COUNCIL ACTION FORM

REQUEST: **AMENDMENT TO THE ADAPTIVE REUSE PLAN AND APPROVAL OF A MAJOR SITE DEVELOPMENT PLAN FOR A FAST FOOD RESTAURANT AT 2615 GRAND AVENUE**

Ed Kaizer represents the property owner of 2615 Grand (Grand 1350 LLC) and is requesting an amendment to the Adaptive Reuse Plan (ADP) and approval of a Major Site Development Plan to allow a fast-food restaurant (KFC) with a drive-through on the property. The proposed new fast-food project alters the current approved ADP, resulting in the need for an amendment with a Major Site Development Plan.

SHEET TITLE
LIFE SAFETY PLAN

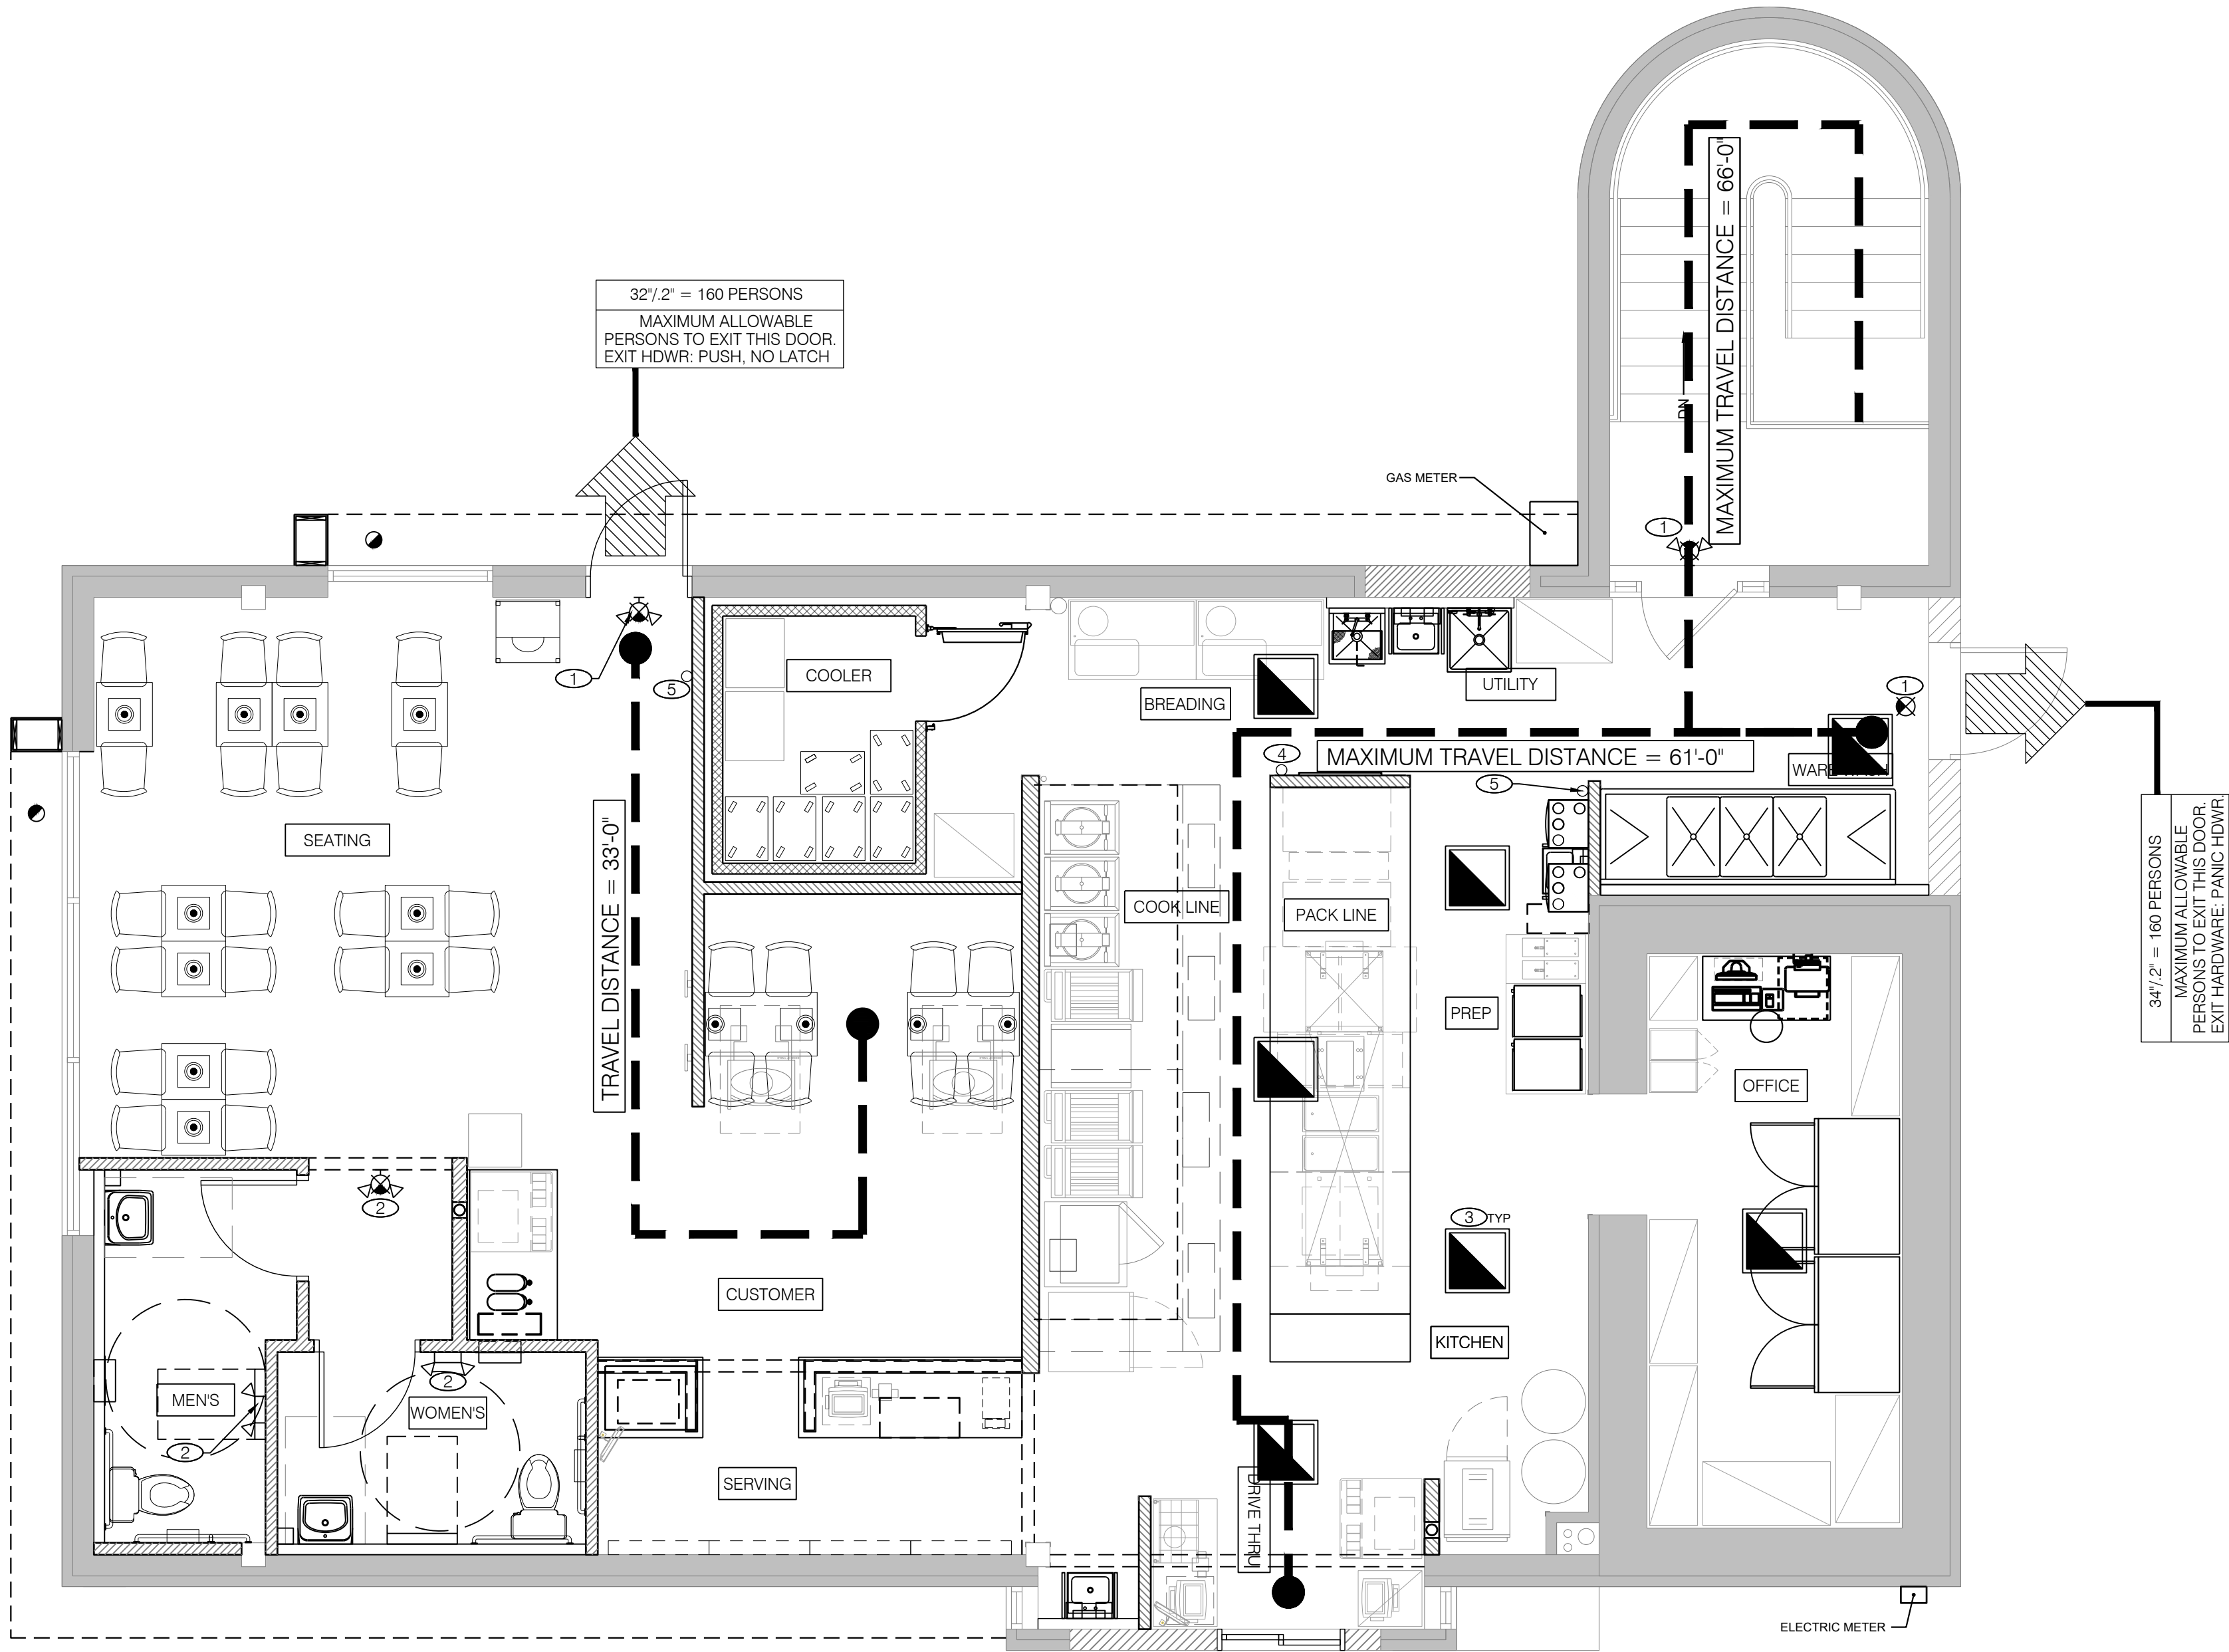
A new 6-inch water line is shown on the site plan serving the building. This is no longer required. The existing 1-inch line is adequate to serve the proposed use, as a requirement to install a sprinkler system for basement is no longer applicable following removal of internal storage room doors that previously restricted hose access.

No sprinkler system is required if all rooms in the basement remain without doors and accessible with a hose.

EXTERIOR
ELEVATIONS

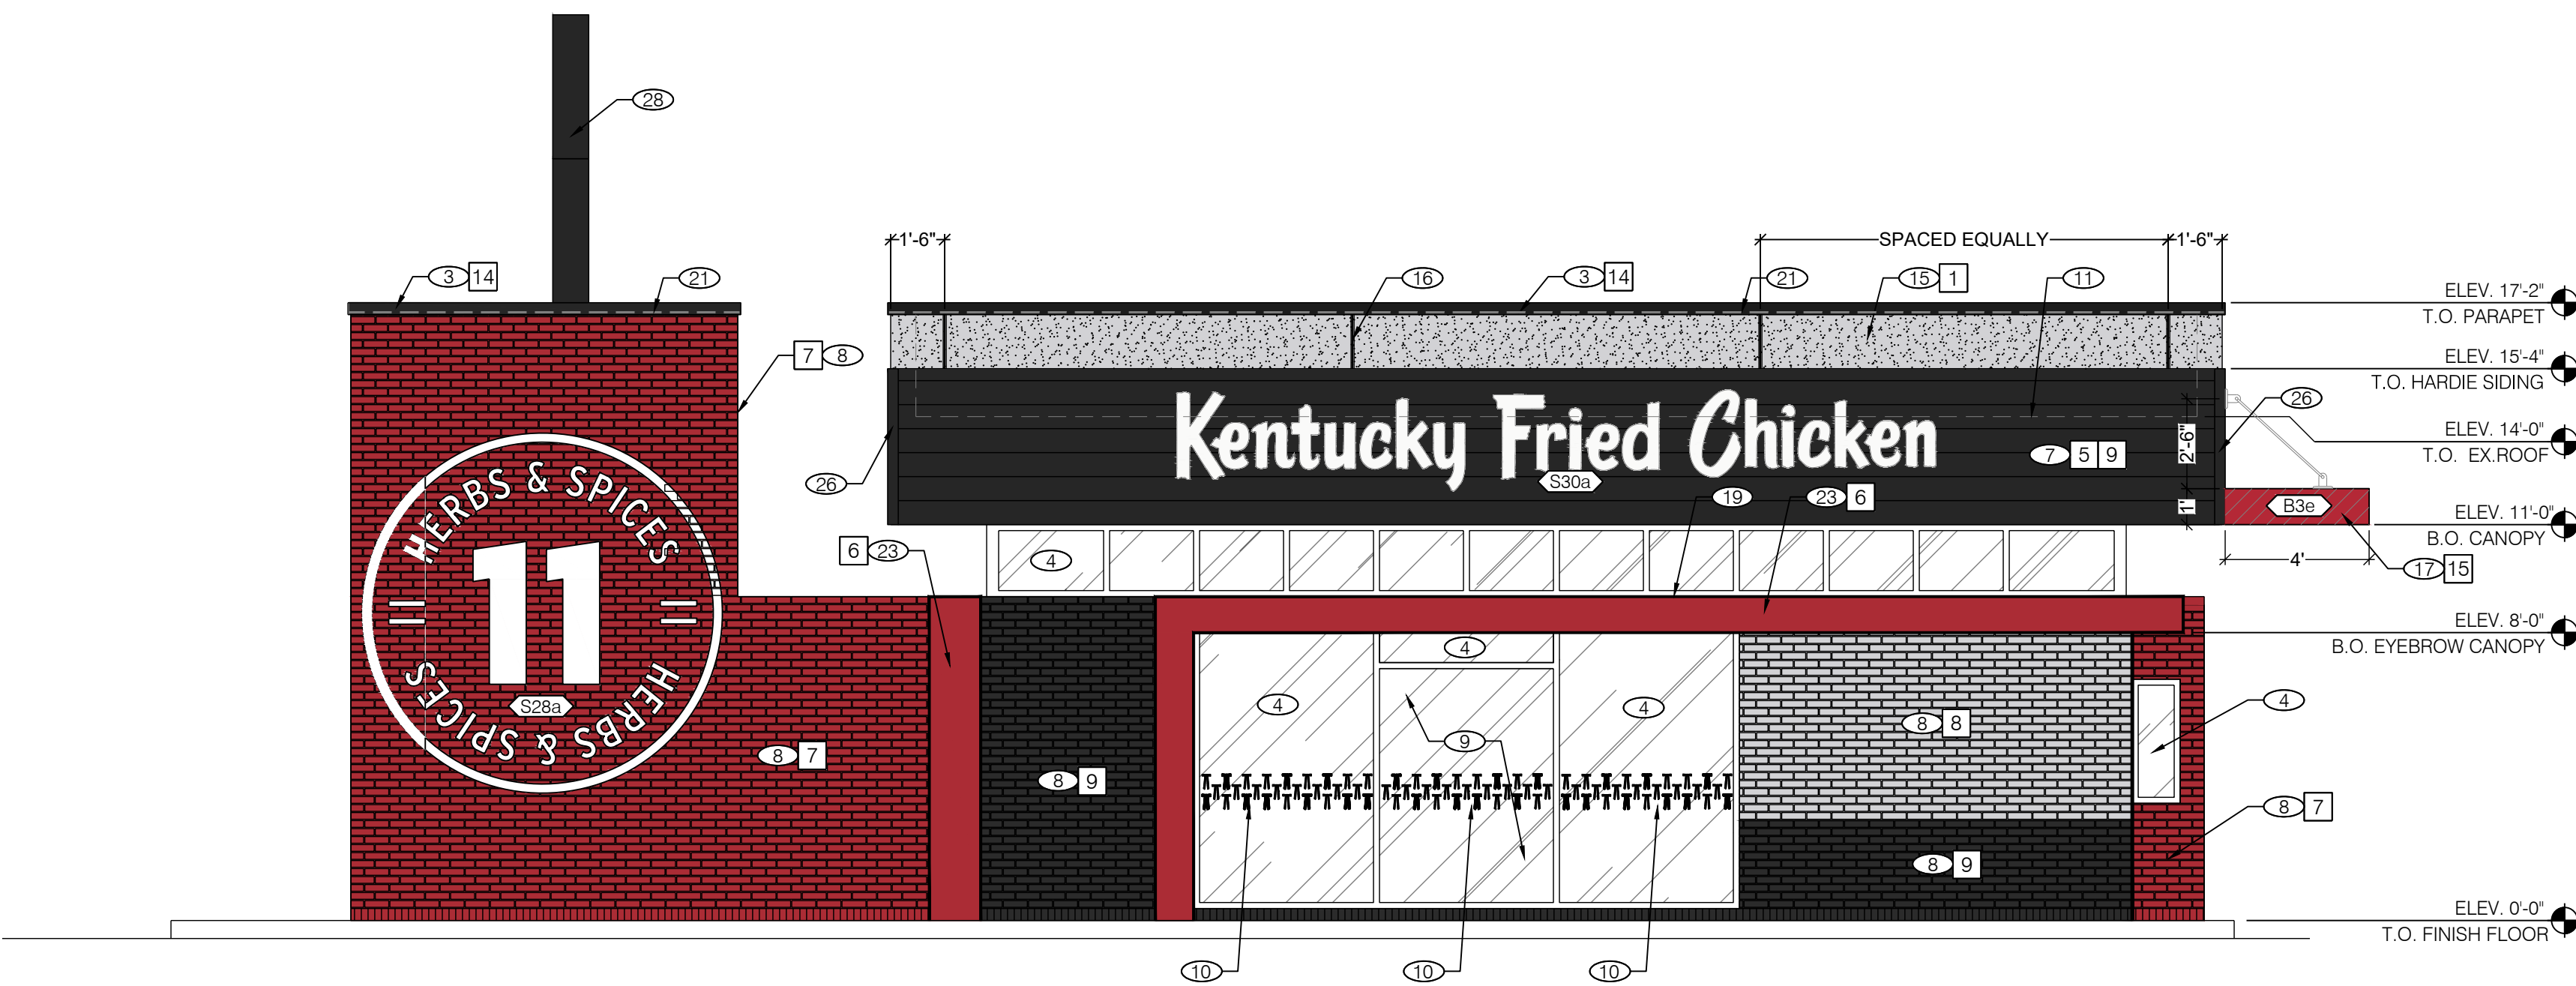
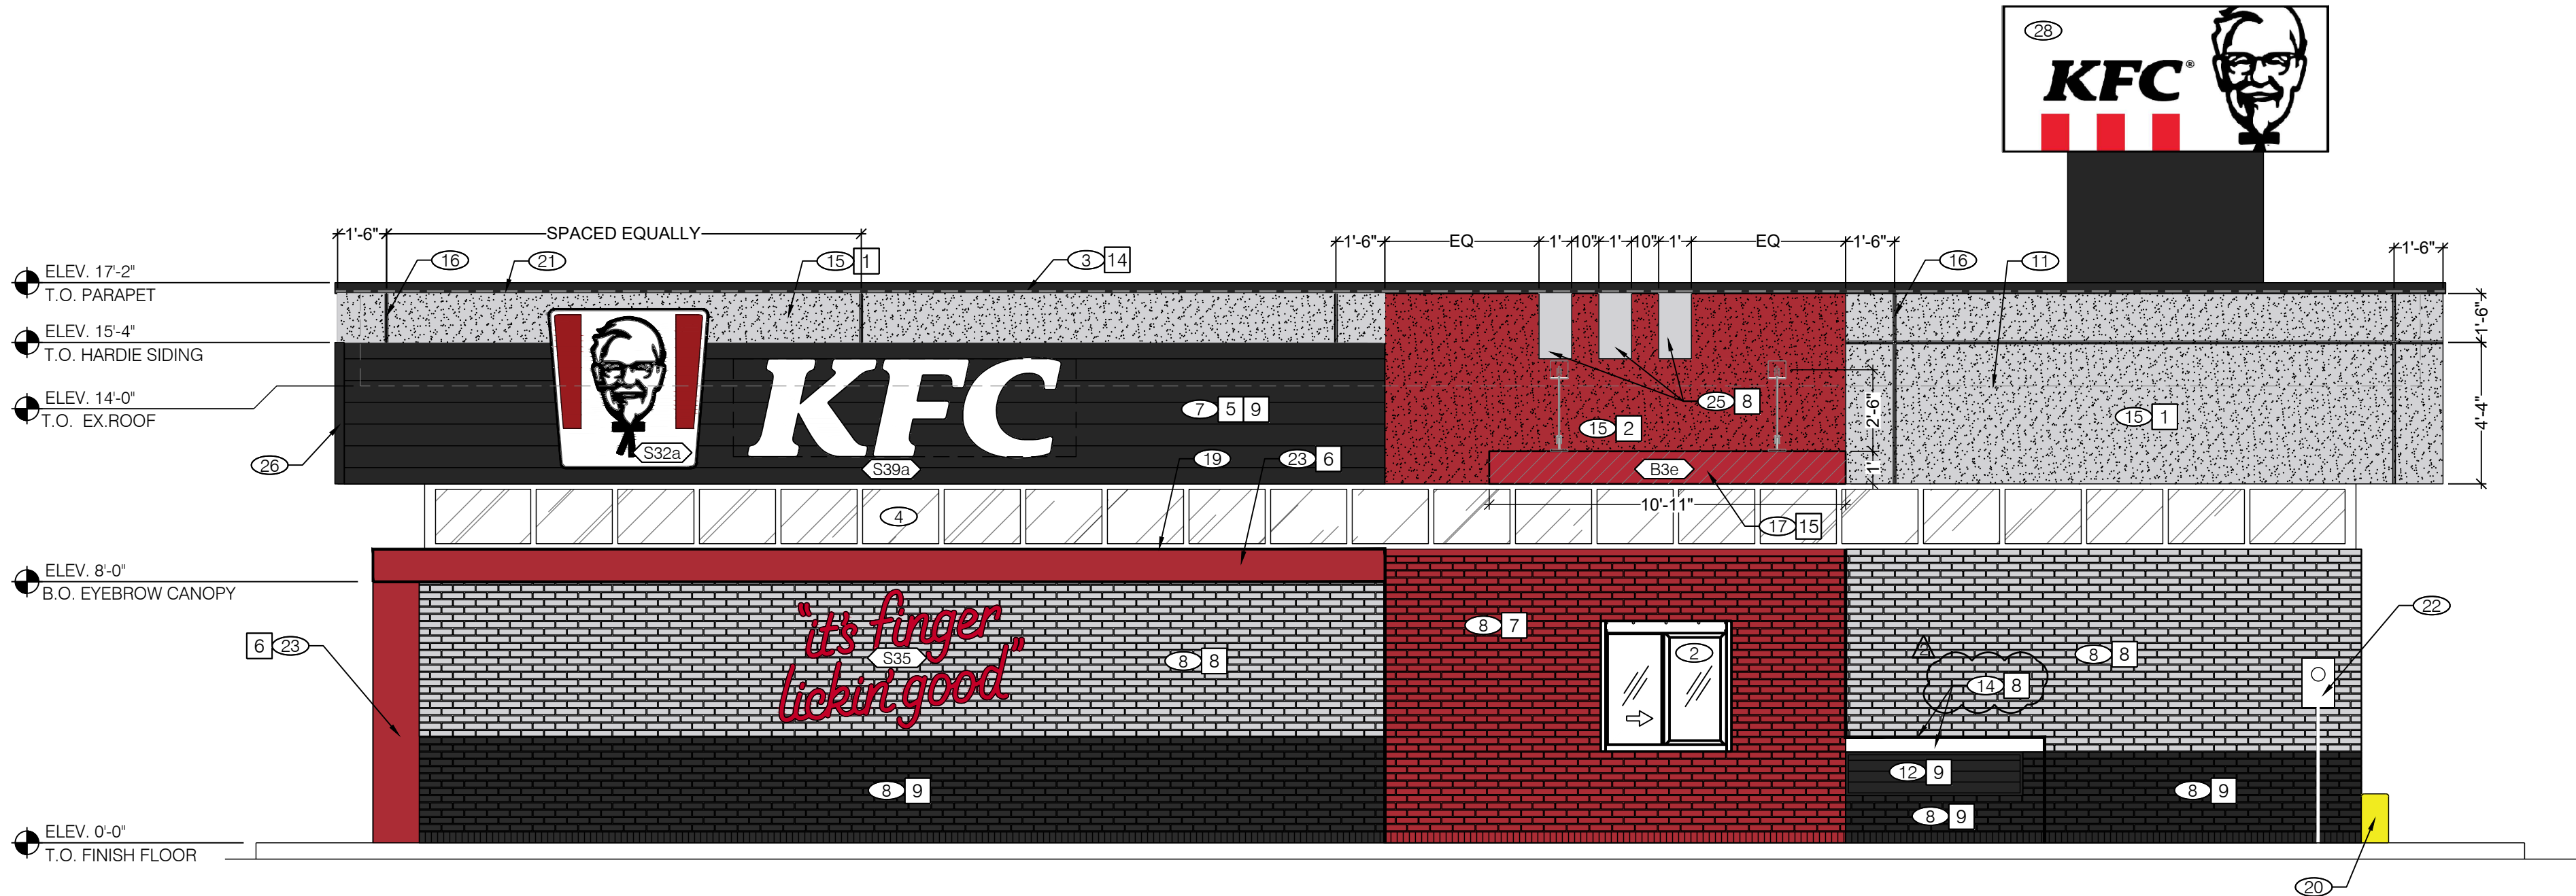
The brick will be painted and parapet rebuilt. The existing transom windows that wrap all four sides of the building will be maintained.

A new primary entrance will be on the south side of the building, adjacent to the existing parking area on the site. While the entrance to the building facing Grand will be removed, it will be replaced with windows into the dining area. The overall design including the retention of the brick and improved fenestration are consistent with contemporary commercial design qualities and the Mall site development overall.
